CITY OF MASSILLON, OHIO
WWTP UPGRADE 2000

PRIMARY GALLERY CABINETS SECOND FLOOR DEMOLITION PLAN

JOB NO.
E9031
DATE
3/24/00
SCALE
1 1/2" = 12"
SHEET
EP246-D

SKETCH "A"

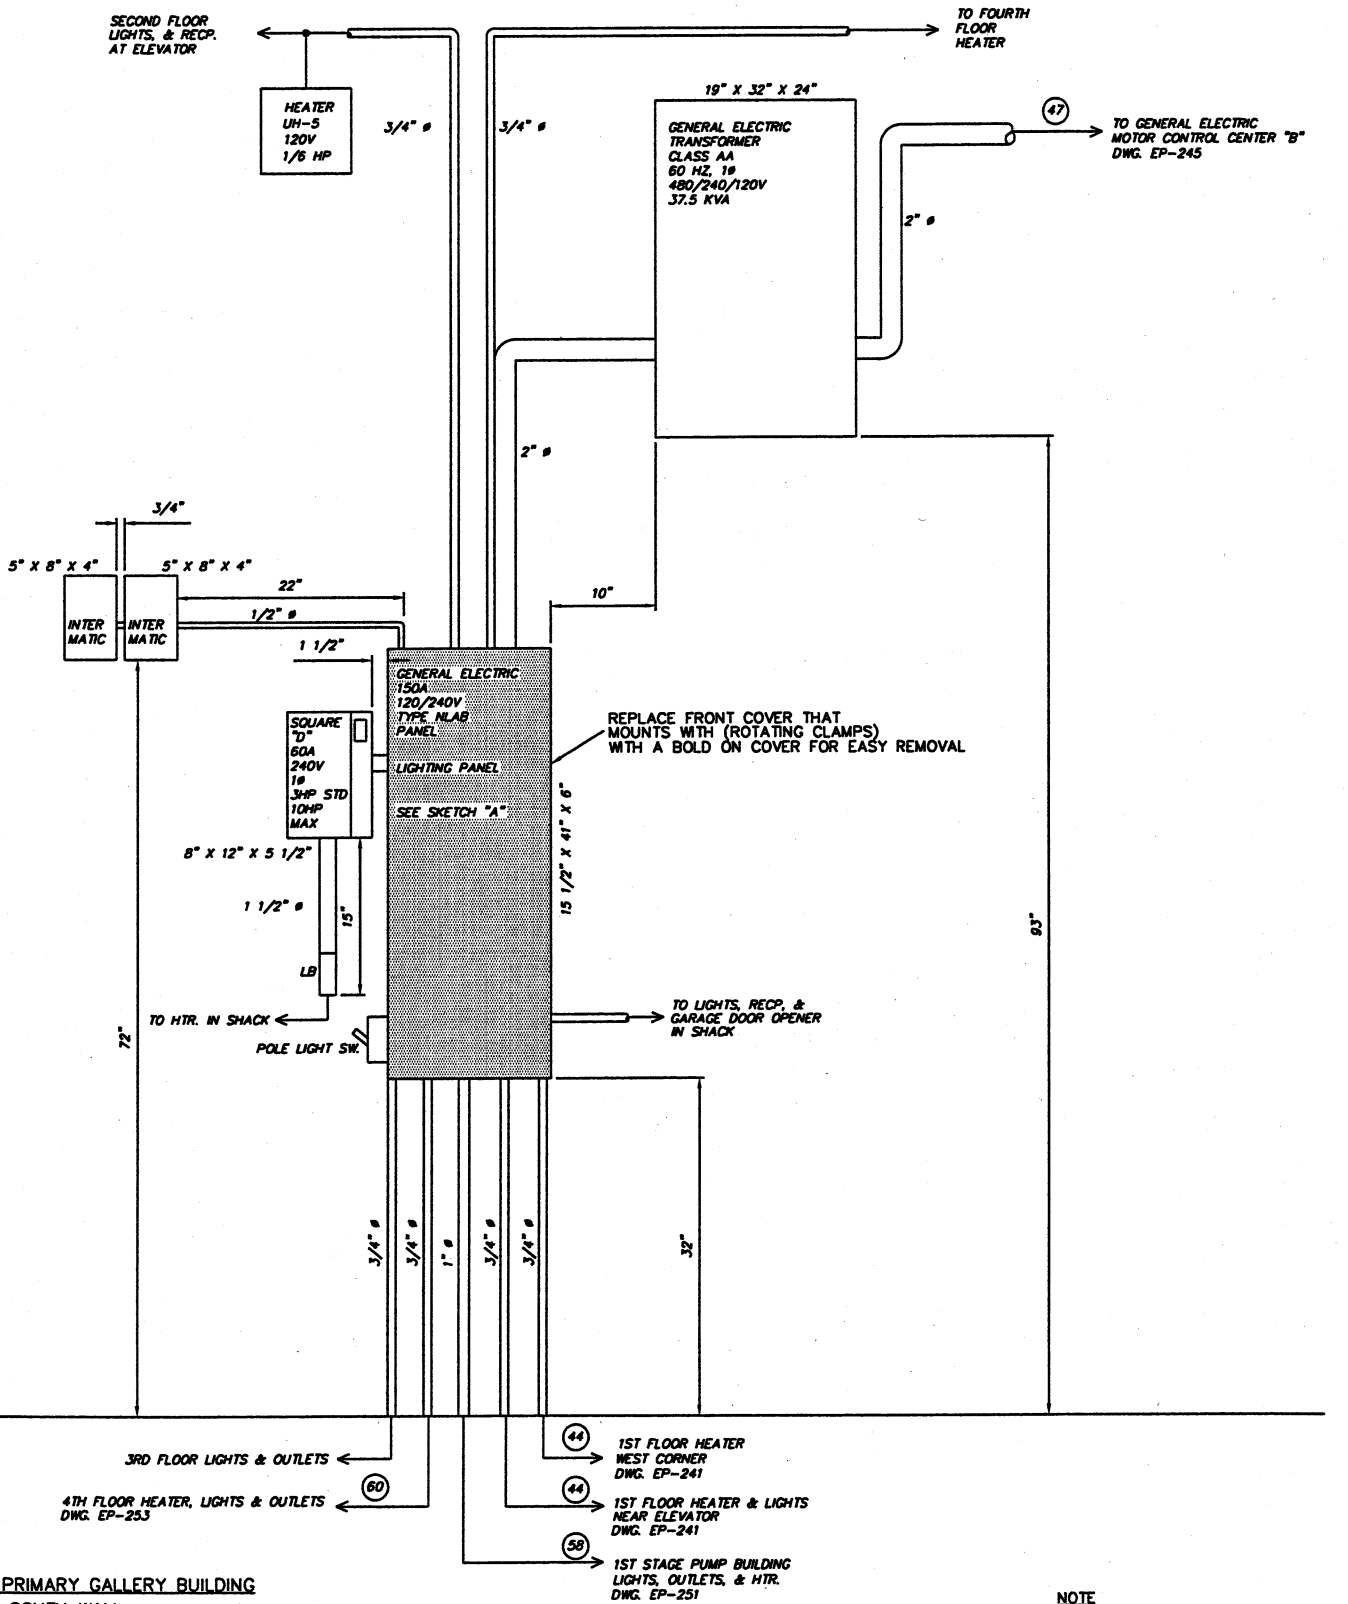
NOTE:
THERMAL IMAGING REPORT INDICATES
BAD CONNECTIONS (HOT SPOTS) ON BREAKERS
#7 & #11. CLEAN CONNECTIONS & WIRES AND RECONNECT.
